**Illinois Department of Transportation**

## **ADDENDUM NO. 1**

DuPage Airport

Project Description – Construct South Flight Center, Phase 4.

**NEW/ ADJUSTMENT/ RELOCATED  
BASE MOUNTED MEDIUM INTENSITY LIGHT**

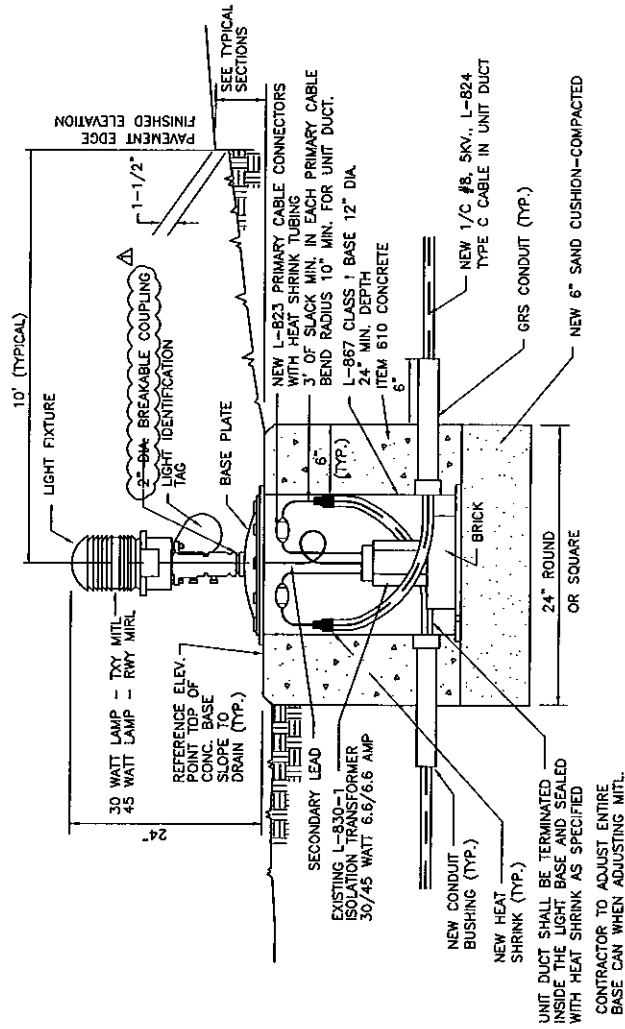
Reason for Addendum: Revise detail for “NEW / ADJUSTMENT / RELOCATED BASE MOUNTED MEDIUM INTENSITY LIGHT” on Sheet 25 of 36 to delete reference to “ 2” DIA. ” from the “BREAKABLE COUPLING” call out.

A revised detail for “NEW / ADJUSTMENT / RELOCATED BASE MOUNTED MEDIUM INTENSITY LIGHT” is attached.
